Urban Design Review Panel Comments

| Application number | DP2019-3135 | |
| Municipal address | 1216 8 St SW & 832 13 Av SW | |
| Project description | New: Retail and Consumer Service, Dwelling Unit (1 building) | |

(i10) Northeast View of 8th and 13th – Retail Entry

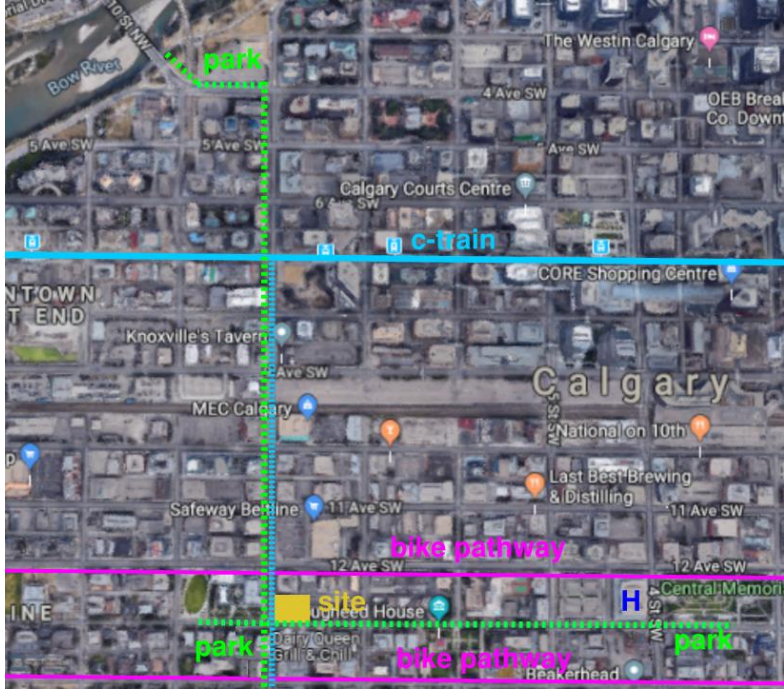
| Urban Design Element | |
|--|---|
| UDRP Commentary | <p>The location of the building is a key corner between two important streets, the 8th Street corridor and the 13th Avenue Greenway. The presented material did not fully reflect the importance of this intersection and did not integrate the elements of the 8th Street master plan. A color landscaping plan may provide better information, however in the current form it is lacking and more emphasis on the public realm at this corner should be given to indicate its significance.</p> <p>The main tower portion may be improved through some variation or articulation, as it appears repetitive and uniform in its current design. Incorporation of different materials or patterns, or the introduction of more changes in plane, would create a stronger visual presence for the building at this prominent corner.</p> |

| Urban Design Element | |
|--|---|
| Applicant Response | <p>After discussions with Dennis Hoffart David Down, and others at the City – the plans have been revised in four important ways:</p> <p>a.) Adhering to the 8th Street Master Plan</p> <ul style="list-style-type: none"> incorporating the planting and paving requirements making the building feel all-inclusive at the pedestrian level by defining the prominent corner of 8th & 13th. Articulating the ground level architecture along with strategic coloured materials help give the corner and thus the building an identity. creating an interactive building base by allowing retail units and potential outdoor seating <p>b.) Adhering to the 13th Avenue Heritage Greenway Plan</p> <ul style="list-style-type: none"> no exact master plan exists for this space, however, we have followed the precedent set in other areas along 13th such as: planting and paving requirements outlined in the 13th Ave Heritage Greenway Plan incorporating the correct setbacks and clearances outlined in the Greenway Plan public space adjacent to 13th Ave sidewalk with seating, planting, and lighting to help engage the pedestrian or residents of the building additional planting adjacent to neighboring site which assists in describing the transition from the retail portion of 8th to the residential access portion off 13th. <p>c.) Articulating the retail entryways along both streets (refer to images)</p> <ul style="list-style-type: none"> entry glazing/glazing at retail openings have been setback 600mm from building face to create a uniform |

- retail entry at the corner of 8th & 13th recessed significantly to create a dynamic inviting street corner

d.) Differentiating the canopy to brighten and celebrate the intersection

- the canopy on the corner of 8th & 13th has a tempered glazing over a white grid pattern to allow light to shine down and highlight the corner. The canopy itself at this location is lit with soft linear lights within the grid to illuminate the canopy at night, still highlighting the corner. The corner then appears to lit both day and night. The continuous soffit canopy is solid on either side of the opening at the corner intensify the light in the corner.
